## Product Change Notification (PCN)

Change Notification: **PCN-US-20141231-IDC**

Description of changes: **Change of Production Location  
Change of New Tools  
Change of Part Numbers**

Products Affected: **AWHW2-26G-SMD-R**

**AWHW-26G-SMD-200**  
New Version

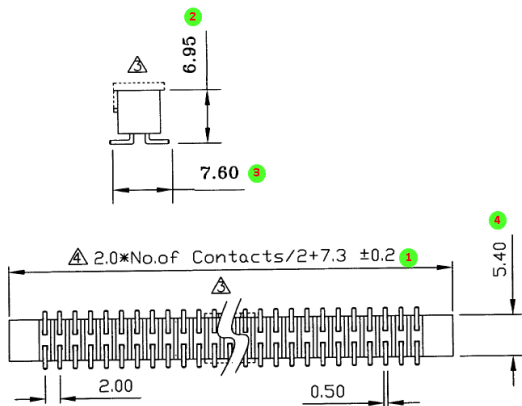
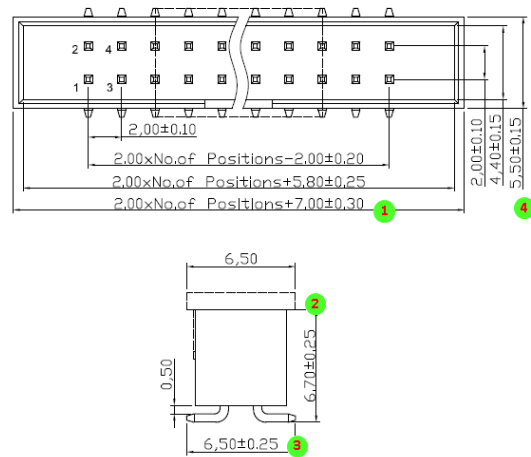
1. Amendment of the specification
2. Current Rating: new: 1.5AMP
3. Insulation Resistance: new: 1000MΩ min
4. Operation Temperature: new: -40°C to +105°C
5. Contact Material: new: Brass
6. Change of dimensions, see sheet 3
7. Listed drawing # replaces all prior drawings, see sheet 2

- 1)  $+7.3 \pm 0.2$
- 2) 6.95
- 3) 7.60
- 4) 5.40

- 1)  $+7.00 \pm 0.30$
- 2) 6.70
- 3) 6.50
- 4) 5.50
